Middletown Public Library  
Main Branch  
55 New Monmouth Rd Middletown, NJ

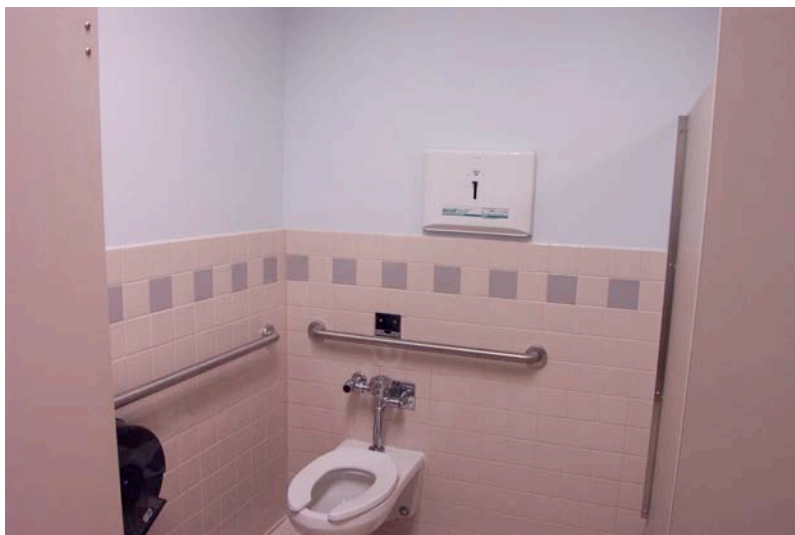
2. The front ramp has 8 sections with the following running slope measurements, contrary to ANSI section 405.1 and ADAAG section 4.8.1.
  - a. The second section from the bottom has a slope of 6.2%.
  - b. The third section from the bottom has a slope of 6.4%.

- c. The fourth section has a slope of 5.5%.
- d. The fifth section has a slope of 5.8%.

- e. The sixth section has a slope of 4.1%, which is within the guidelines.
  - f. The seventh section has a slope of 4.9%, which is also fine.
  - g. The eighth section has a slope of 5.3%.
3. The men's bathroom in the library has the following problems to be corrected.
- a. The toilet is mounted at 19 inches on center from the side wall, contrary to ANSI section 604.2 and ADAAG section 4.17.3
  - b. The toilet paper dispenser measures 44 inches off of the back wall, contrary to ADAAG section 4.16.6.
  - c. The seat cover dispenser measures 60 inches above the finished floor, contrary to ANSI section 308.2.1 and ADAAG section 4.27.3.
